## PORT PHILLIP CONSERVATION COUNCIL INC.

4<sup>th</sup> July 2024

### PROPOSED FRANKSTON PLANNING SCHEME AMENDMENT C160FRAN

Figure 6.5: Depth to water table in the PPB region (source: CeRDI, 2020)<sup>26</sup>. Locations of the detailed conceptualisations – Werribee, Mentone to Frankston, and Nepean Peninsula delineated by blue broken lines

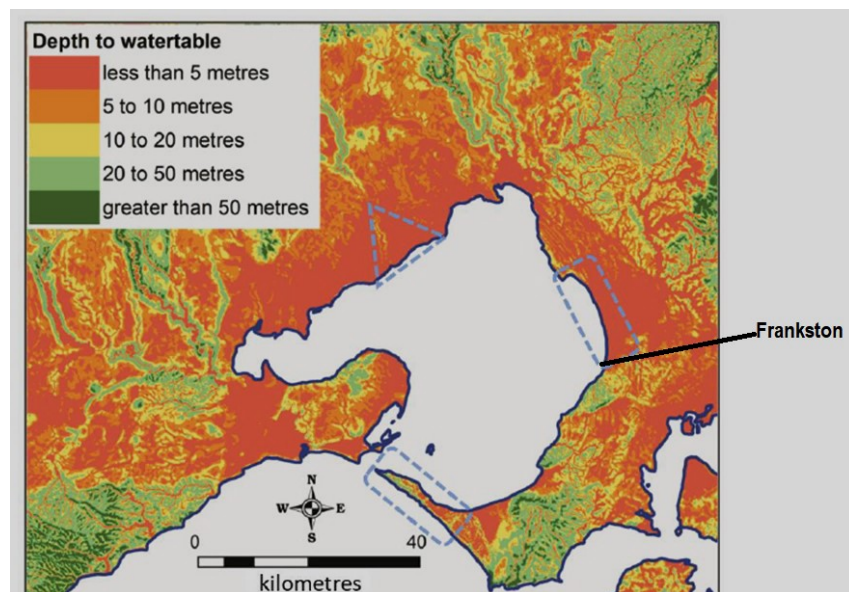
63. CSIRO’s above map (Figure 6.5) indicates depth to water table in coastal Frankston is less than 5 metres. Council must be aware that ground water in much of Precinct 4 and

Kananook Creek area is relatively high, thus likely to be breached by deep excavations for high rise developments.

64. We understand that Bay water levels and the level of Kananook Creek is a key determinant of the groundwater level in this location, and the invert of the creek is at about  $-1.0$  m AHD<sup>27</sup> (i.e.  $-1.0$  m below mean sea level) and the mean creek level is only slightly over  $0.0$  m AHD over most of its length, So -

- Dunes between the Bay and the creek must have a water level above  $-1.0$ m AHD and more than likely be at about mean creek water level of  $0.0$  m AHD or higher in winter. If these dune areas are  $3 - 4$  m AHD the groundwater is therefore  $3$  to  $4$  m below the surface.

- Land east of the creek slowly rises, as does the groundwater table. But within  $20-30$  metres of the creek the groundwater level would likely be just above the mean creek water level. If the sand deposits here are at  $4$  to  $5$  m AHD, the groundwater is likely to be at a depth of  $4$  to  $5$  m below ground level and even higher in winter.

- If excavations for foundations and basements in this general area were deeper than  $4$  to  $5$  metres, we expect groundwater pumping could be required, perhaps indefinitely as per the nearby Quest building on east side of Nepean Hwy. - where basement pumps run 24/7/365.

- If high rise development was permitted in Precinct 4 adjacent to Kananook Creek, once disturbed by excavations, breached groundwater would likely have a high sediment load. We assume it could be disposed of Kananook Creek, altering its ecology and contributing to flooding events. (and likely contrary to PS Clause 12.03-1S river and riparian corridors).

Figure 6.8: Water table salinity in PPB region (from CeRDI, 2020), CSIRO PPBay Coastal Hazard Assessment Study 2022 Page 122

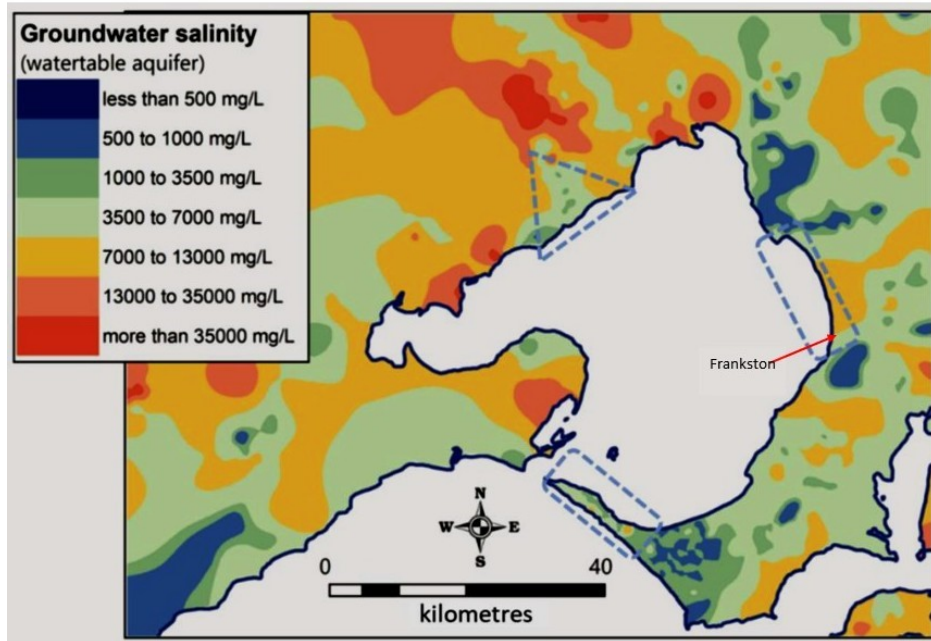
65. We understand brackish groundwater is generally defined as having total dissolved solids (TDS) of 3,000 – 10,000 mg/litre and can damage concrete and steel basement infrastructure.

66. In its PPBay Coastal Hazard Assessment 2022<sup>28</sup> only released in January 2024, CSIRO, assessed three coastal areas, one being Mentone to Frankston, which CSIRO noted has numerous assets potentially at risk for groundwater hazard, and that groundwater salinity at Frankston likely ranges from 3500 to 13,000 mg/litre salinity.

67. CSIRO also noted since most of the shallow groundwater is saline to some extent (As per Figure 6.8 above), salt attack on building and construction materials, through chemical corrosion and erosion of materials by prolonged wetting and drying cycles may be significant.
